Onderwerp: Gelderland Central Power Station

Subject: Report R21.10976/1/1DW of 18-01-2021

Subject: Report C2002/MM/D001 dated 25-02-2021

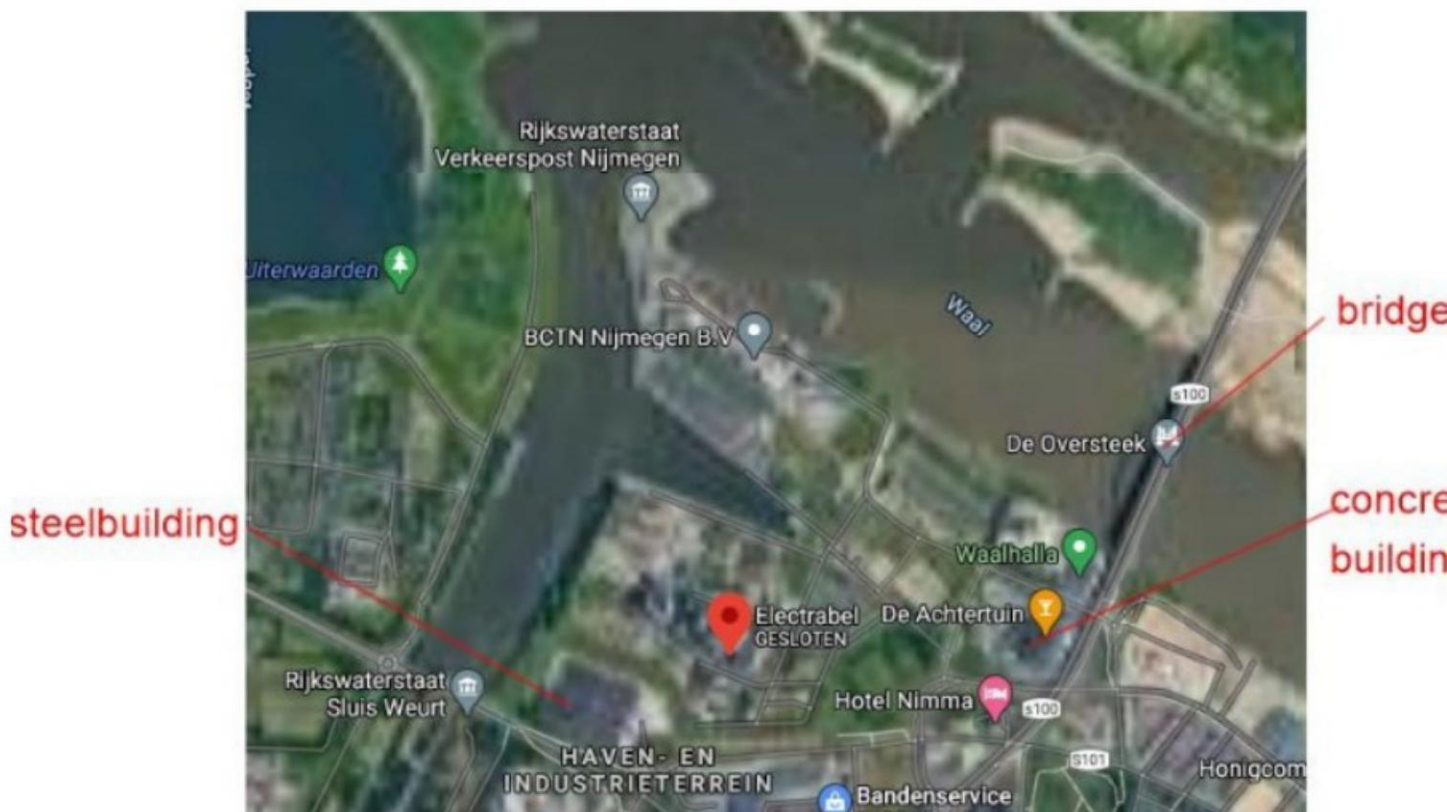
However, it is not clear to us how the risk to the surrounding structures was determined. See the map fragment. We would like to know why you include the "De Klok" building (steel building) and the bridge in your assessment and not the concrete masonry building east of the FGD construction.
